**Request for Additional Information No. 266, Supplement 7**

**U.S. EPR Standard Design Certification**

**Docket No. 52-020**

**Question 06.02.01.04-4:**

**Figure 06.02.01.04-4-1—MSLB Containment Peak Pressure Comparisons**

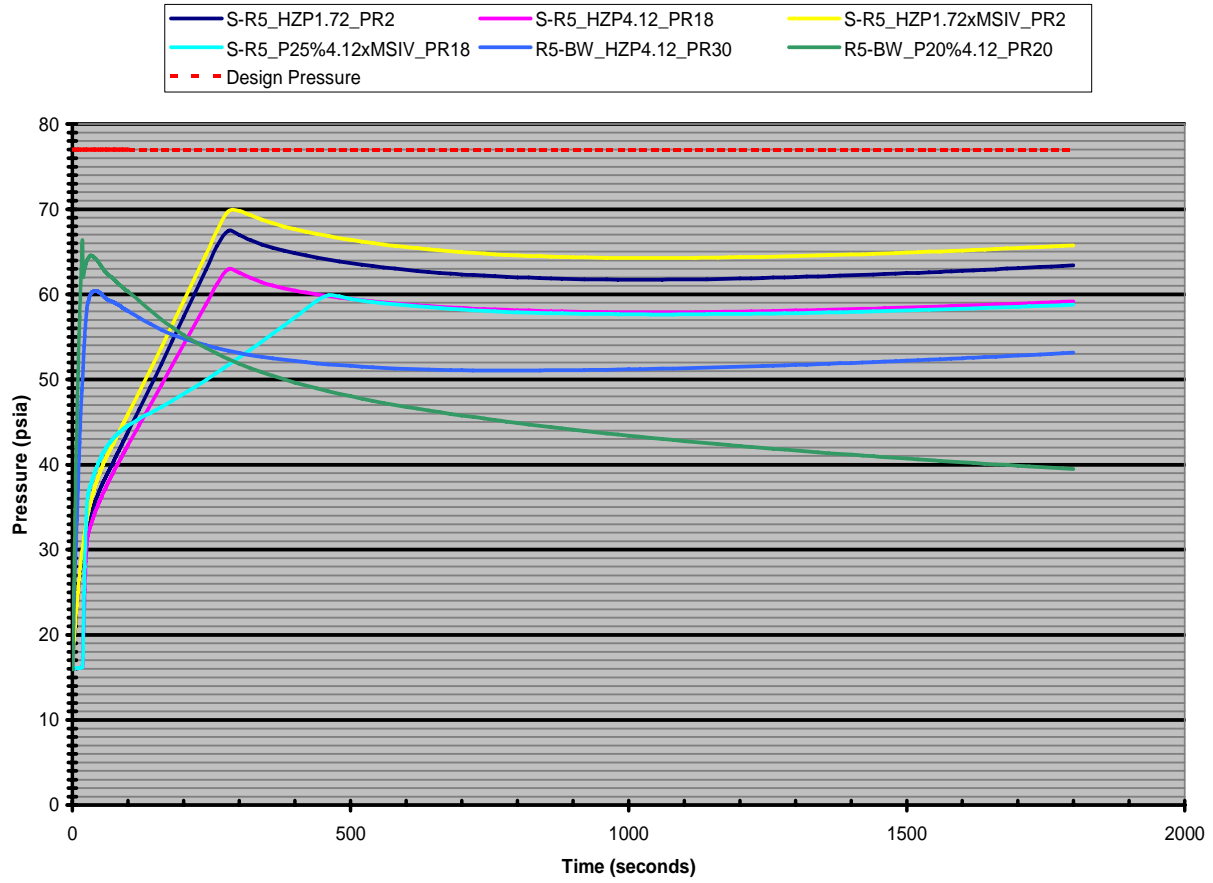
This question relates to conservativeness of the secondary system break mass and energy release calculations in FSAR Section 6.2.1.4. In RAI #82 6.01.02.04-1d the staff questioned the assumptions used to calculate reactor power following a main steam line break and the effect of these assumptions on containment analysis. In the response AREVA provided a curve of reactor power vs. time for the MSLB case calculated to produce the highest calculated containment temperature and pressure. This was for a postulated double ended break with the reactor at an initial power level of 50%. Offsite power was assumed to remain available so that the reactor coolant pumps would continue to operate. The break flow was assumed to be limited by the area of the flow restrictors in the steam generator nozzles to 1.4 ft<sup>2</sup>. The RELAP5/Mod2-B&W computer code was used to model the reactor system. No return to power was calculated even though the most reactive control rod was assumed to be stuck and to not enter the core following reactor trip.

Figure 06.02.01.04-4-1 shows the results of the four U.S. EPR FSAR Tier 2, Chapter 15 S-RELAP5 methodology-based GOTHIC calculations previously mentioned, together with GOTHIC calculations (RELAP5-BW M&Es) of the limiting U.S. EPR FSAR Tier 2, Chapter 6 analysis of record (DEG MSLB from 20 percent RTP) (**green curve**) and a U.S. EPR FSAR Tier 2, Chapter 6-based double-ended MSLB from HZP (**blue curve**). The results indicate:

- The limiting U.S. EPR FSAR Tier 2, Chapter 15-based S-RELAP5 HZP 1.72ft<sup>2</sup> MSLB calculated peak containment pressure (with no credit taken for high  $P_{\text{cont}}$  pressure isolation) is not bounded by the limiting U.S. EPR FSAR Tier 2, Chapter 6-based RELAP5-BW 20 percent power DEG MSLB calculated peak containment pressure.
- The limiting single failure in terms of containment consequences is the failure of the affected SG MSIV to close.
- The limiting U.S. EPR FSAR Tier 2, Chapter 15-based MSLB scenario in terms of containment consequences is the 1.72 ft<sup>2</sup> split MSLB from HZP EOC conditions with failure of the affected SG MSIV to close and no loss of offsite power (LOOP).

The overall results of the S-RELAP5/GOTHIC containment analyses indicate that the limiting Chapter 15-based HZP MSLB scenario is not bounded by the corresponding U.S. EPR FSAR Tier 2, Chapter 6 limiting case MSLB scenario although no credit is taken for high containment pressure ( $P_{\text{cont}}$ ) isolation in any of the S-RELAP5 analyses.
